# Development Engineering Formal Referral Response

<b>Referral Officer:</b>	Artemis Bacani
<b>Officer:</b>	Nish Goonetilleke
<b>Council Reference:</b>	PLN23/0819
<b>Address:</b>	Road Seg (Partial), Alexandra Parade, Fitzroy North
<b>Proposal:</b>	Buildings and works associated with the construction of car parking spaces, roadworks, including fencing on land within the Special Building Overlay.
<b>Comments Sought:</b>	<ul style="list-style-type: none"><li>• The proposed car parking spaces/configurations within the median strip;</li><li>• All vehicle access arrangements; and</li><li>• Clarify if swept path diagrams are required.</li></ul>
<b>Disclaimer:</b>	Council's Development Engineering unit, provides the following advice based on information provided in the referral request memo referenced above.

Drawing No. or Document	Rev	Dated
Creo Consultants	CRE-CV-DR-0120 <i>Proposed Civil Functional Layout Plan</i>	C	13 December 2023
Vicroads	SD 3143 <i>Standard Drawing Fence Welded Mesh</i>	A	1 July 2005
Niche Studio	<i>Proposed Roadworks</i>	1.3	9 January 2024

Vehicle Turning Movements –  
Alexandra Parade Slip Lane

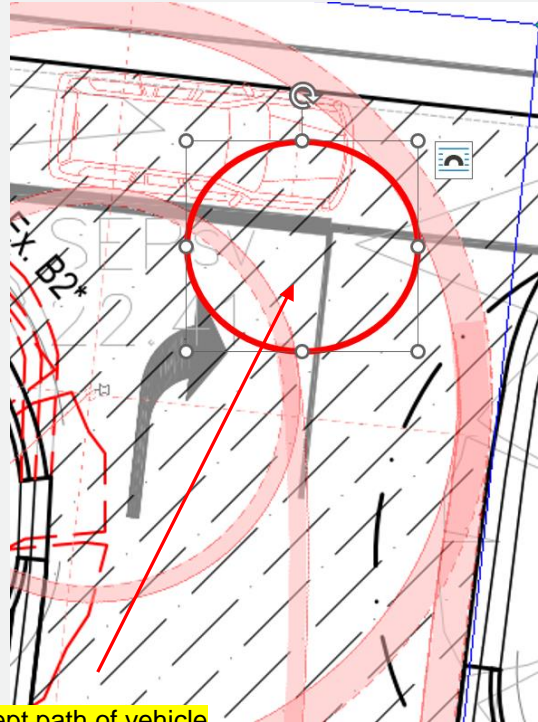
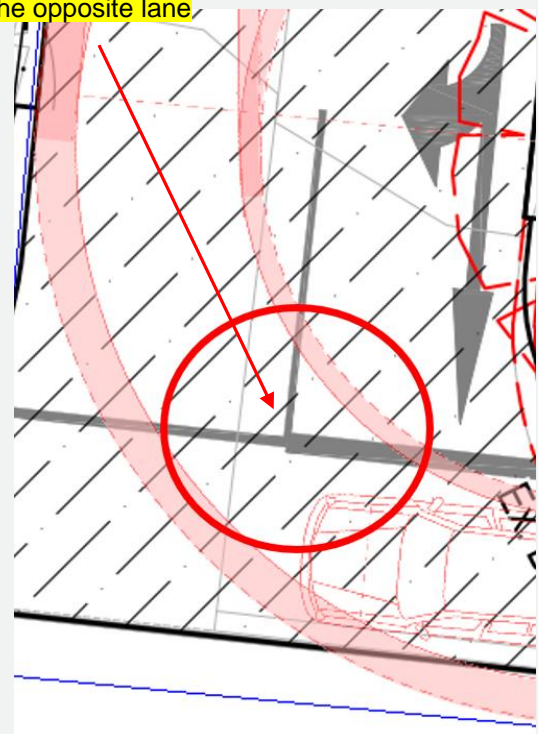
Swept path diagrams have not been provided to demonstrate turning movements into and out of the Gore Street via the Alexandra Parade slip lanes.

The diagrams below show the swept path for a B99 design vehicle traversing into the opposite traffic lane.

swept path of vehicle  
traversing into the corner  
of the opposite lane

Item	Details
Vehicle Turning Movements – Car Park Entry and Exit	The applicant is to submit swept path diagrams to demonstrate vehicle turning movements into and out of the car parks.
Width of Car Spaces	The applicant is to dimension on the drawings the width of the car spaces.
Width of Aisle	The applicant is to dimension on the drawings the width of the aisles.
Vehicle Turning Movements – Car Spaces	The applicant is to submit swept path diagrams to demonstrate entry and exit movements into and out of the car spaces.
Vehicle Turning Movements – Alexandra Parade Slip Lane	The applicant is to submit swept path diagrams to demonstrate turning movements into and out of the car parks from the slip lanes.
Turnaround Area – Parking Spaces at the End of Car Park	<p>The applicant is to confirm the use of the car spaces at the end of the car parking areas and whether the spaces will be used as a turnaround area for vehicles.</p> <p>Swept path diagrams are to be provided to demonstrate adequate turning movements at the end of the car parking areas to allow vehicles to exit the car park in a forward direction.</p>

Turnaround Area

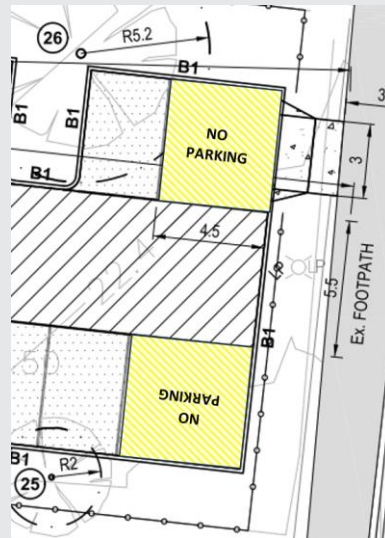
Will all or some of the spaces at the end of the car parking area be designated with No Stopping restrictions to allow vehicles to turnaround and exit the car park in a forward direction as shown in the diagrams below?
